**Outline of Draft Amendment to ECE Regulation No.46
(Draft Requirements for Driver's Field of Vision of
Immediate Frontward and Sideward)**

Transmitted by the expert from Japan

Japan proposes an amendment to R46 and the outline of amendment is as follows;

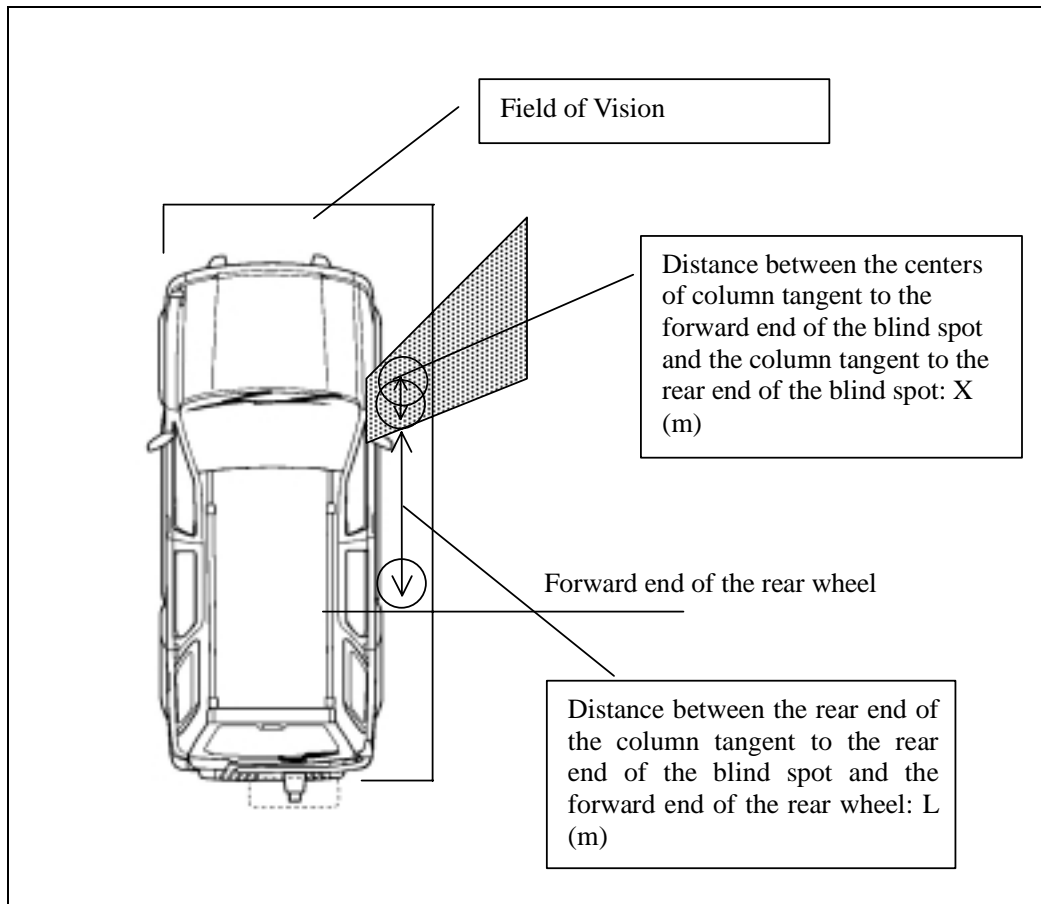
- For vehicles of Category M and Category N of which its weight is not exceeding 7.5 t, at least a part of a column of 0.3 m in diameter and 1 m in height (See 1. in attached sheet) placed proximate frontward and right sideward (passenger side) of the vehicle shall be visible from either the driver's eye points (See 2. in attached sheet) or displaced eye points (See 3. in attached sheet) through either the exterior mirror or a Class VI mirror (new). This requirement, however, shall not apply in case where the said column is directly visible from either driver's eye points or displaced eye points.
- To ensure front direct visibility, a Class VI(new) mirror may be installed with a minimum curvature of 100R.
- In the case above, the blind spots made by the A-pillar and the exterior mirror shall not be regarded as such as long as they satisfy the provisions of the 4. in attached sheet.

- For vehicles of Category N of which its weight is exceeding 7.5 t, at least a part of a column of 0.3 m in diameter and 1 m in height (See 1. in attached sheet) placed inside the field of 2 m frontward and 3 m right sideward (passenger side) of the vehicle shall be visible from the driver's eye points (See 2. in attached sheet) through either the exterior mirror or a Class VI mirror (new). This requirement, however, shall not apply in case where the said column is directly visible from the driver's eye points (See attached sheet 2).
- To ensure front visibility, a Class VI mirror (new) may be installed with a minimum curvature of 100R.
- If this requirement is satisfied, the installation of a Class V mirror is optional.
